Access Compliance Report Public Rights-of-Way (RR Crossings)

Intersection ID: 5967	Main Street: N_TRYON_ST	Location: N/A
ADA ID: 3D1C032CEF7F	Overall Compliance: No	Severity Score: 0.0
Codes/Mitigation Info/Possible Solution		Field Measurements/Component Compliance

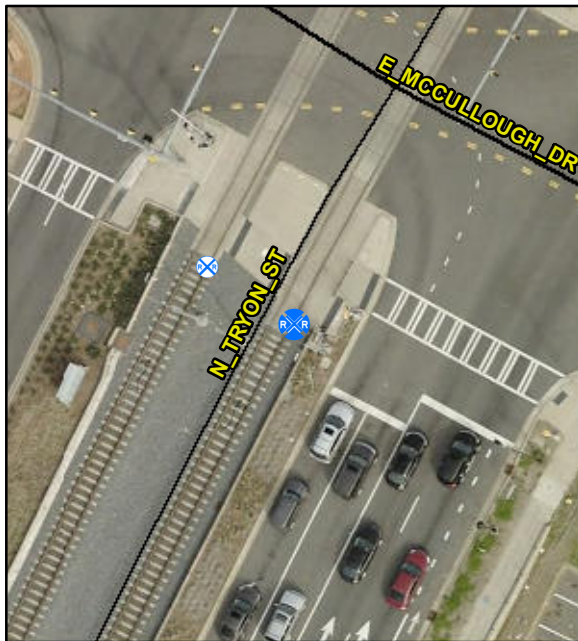
Remove & Replace Detectable Warning System. Provide Pedestrian Gate. Remove & Replace Walking Surface Adjacent to Rail.

R302.7.4, R305.1.4, R305.2.5

Compliance	Description	Data
Yes	DWS Provided?	Yes
Yes	DWS Contrast?	Yes
No	DWS Width (in)	No
Yes	DWS Length (in)	24.0
Yes	DWS Offset (in)	115.0
No	Pedestrian Gate?	No
N/A	DWS Outside Gate?	No
N/A	Rail Type?	LightRail
No	Flangeway Gap (in)	3.0
Yes	Sidewalk Width (in)	122.0
